Woods
Pranil Wadan - Principal Engineer

W-REF: P16-335
25 March 2020

Response to Auckland Council Further Information Request on Stormwater Matters for Drury East

Figure 1: Flow comparison – 10yr

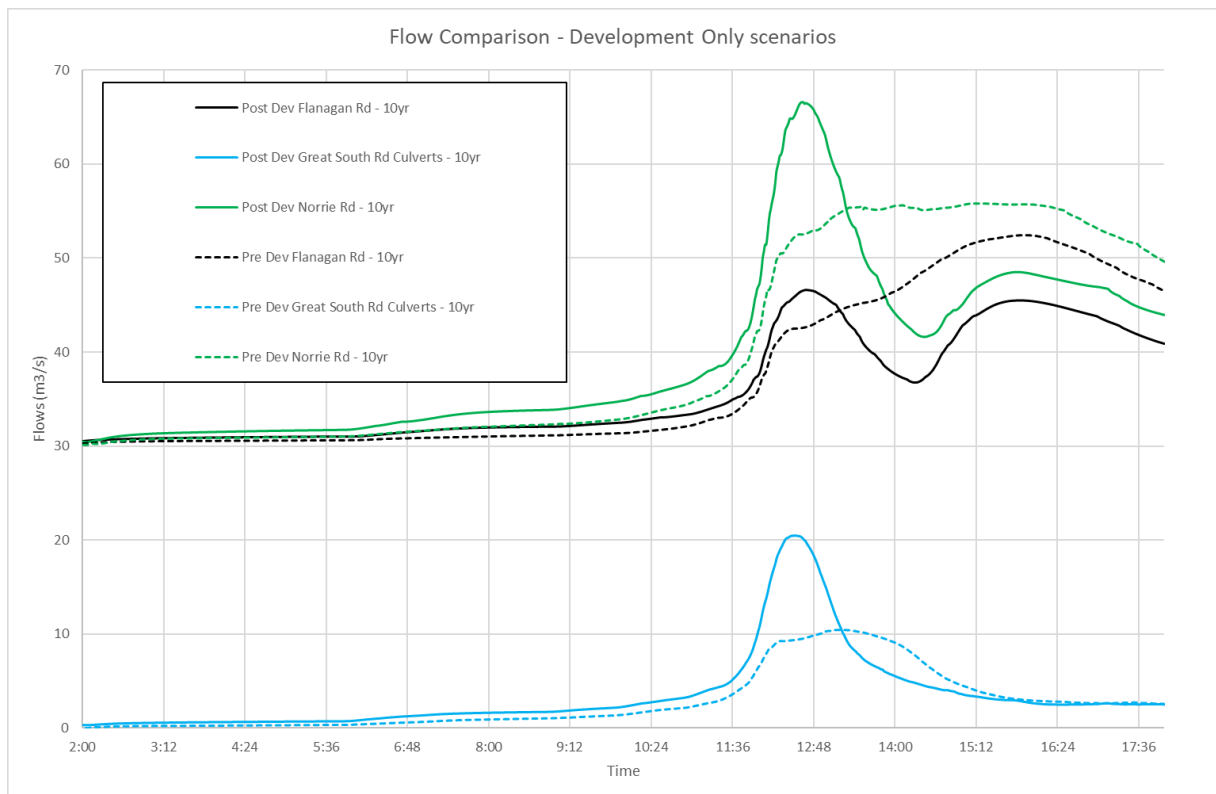
Flows were extracted for the 10yr and 100yr scenarios to understand the differences between the pre and post development scenarios for the 'Development only'. The post development flows are peakier when compared to the pre-development scenario but have shorter time to peak with no lag as seen in Figure 1 and 2 below.

Figure 3: 10yr Flow comparison

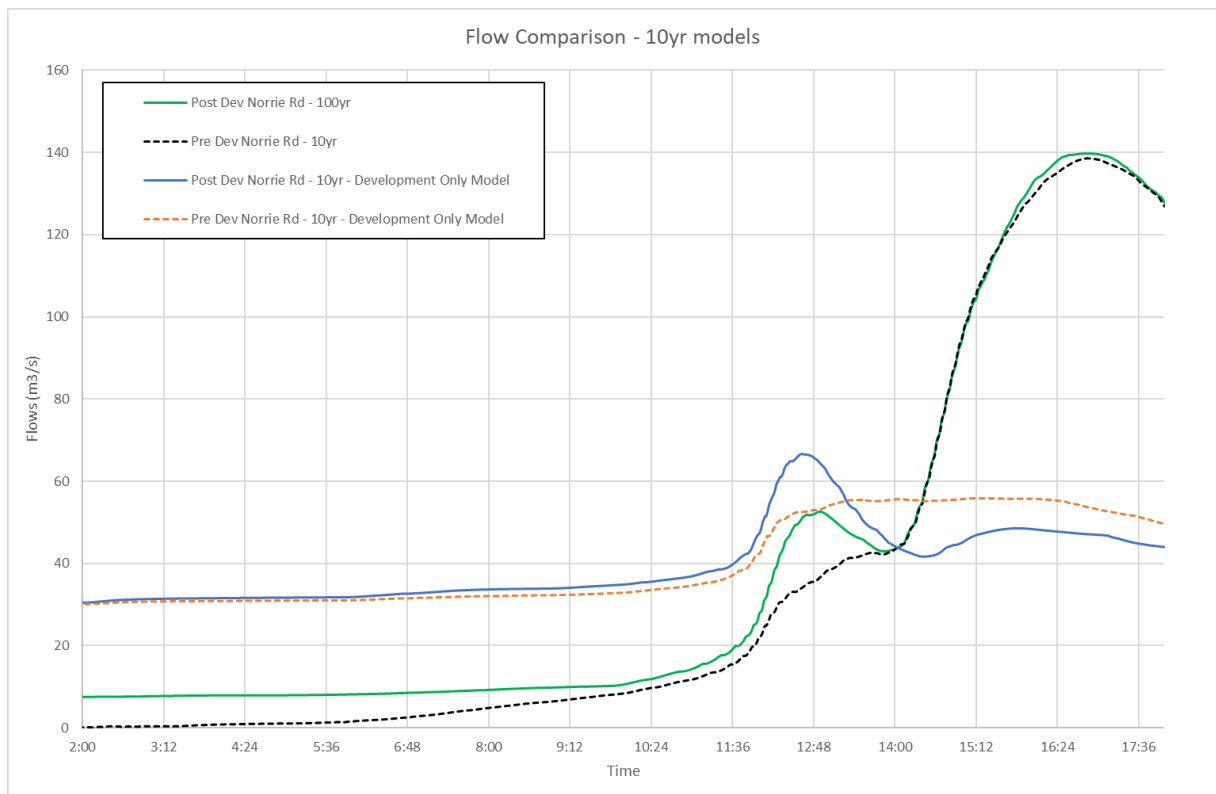
The 10yr flows at Norrie Road bridge were compared for the catchment and 'Development only' models flows which confirm that a 'pass flows' forward approach works better for the proposed development to discharge majority of the flows before the peak of the upstream flows reach Drury township.

This is supported by the building floor risk analysis which shows no increased flood risk to buildings/habitable floors with the 'pass flows forward' approach.
